Biddlestone Orchard, Herefordshire

Appeal Statement

Jubb Project Number 21257

Figure 4.3 Site Access

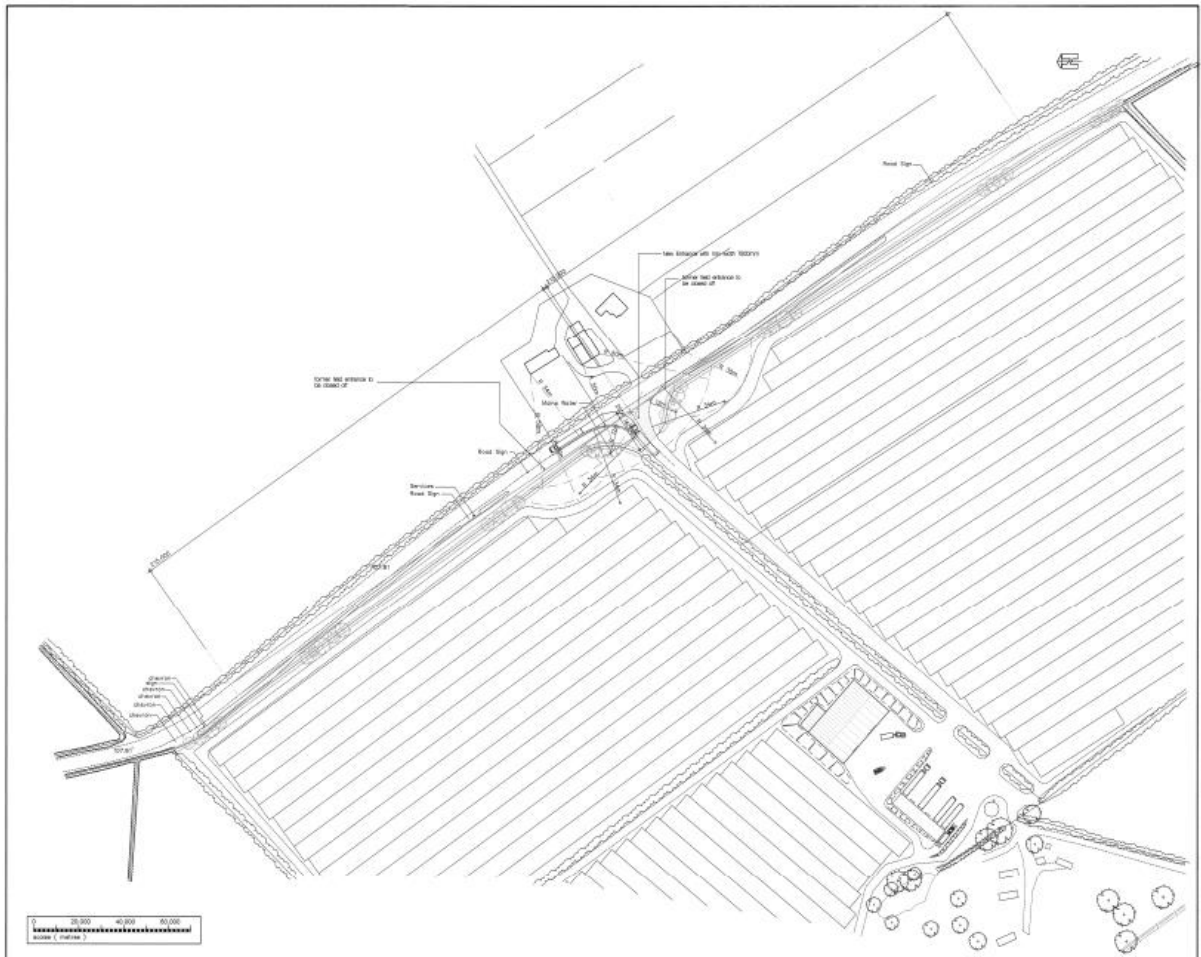
"A plan submitted as part of the access proposed, shows a HGV turning out of the site, however the vehicle shown does not appear to stay on the same side of the road, therefore potentially causing an impact for oncoming vehicles. There is significant concern that the turning movements from this access cannot be accommodated on the A4137. The access should be built to HC industrial access specification, this includes the width of the carriageway into the site and the kerb radius at the access. Please supply a plan showing the correct specification of the access and vehicle tracking with these details included.

A plan submitted as part of the access proposed, shows a HGV turning out of the site, however the vehicle shown does not appear to stay on the same side of the road, therefore potentially causing an impact for oncoming vehicles. There is significant concern that the turning movements from this access cannot be accommodated on the A4137. The access should be built to HC industrial access specification.

- 6.2.5 A recreation of the access junction design has been undertaken by Jubb for the purpose of review and further swept path analysis. Following this review, it is confirmed that the previously proposed access was appropriate in term of dimensions and in accordance with the Herefordshire Council Industrial Use specification. Notwithstanding this, in order to address the LHAs previous concern in relation to the path of left turning heavy vehicles out of the site (i.e. that are shown to slightly overlap the centre of the road) slight adjustments have been undertaken to the northern kerb line at the mouth of the access. The resultant junction drawings (including swept path analysis) are included as **Appendix D** of this Appeal Statement.

- 6.3.1 It is evident that the access proposals have been designed to appropriate standards in accordance with local guidance; the proposed use, and the character of the road network fronting the site. Furthermore, this review has shown that swept path analysis of heavy vehicle movements can be accommodated within the access geometry and overrun of the centreline of the A4137 for left turn out vehicles (a previous concern for the LHA) can be prevented with some very minor adjustment of the northern kerblines of the junction. It is noted that such minor alterations to kerb lines could be carried out at S278 stage as part of detailed design.
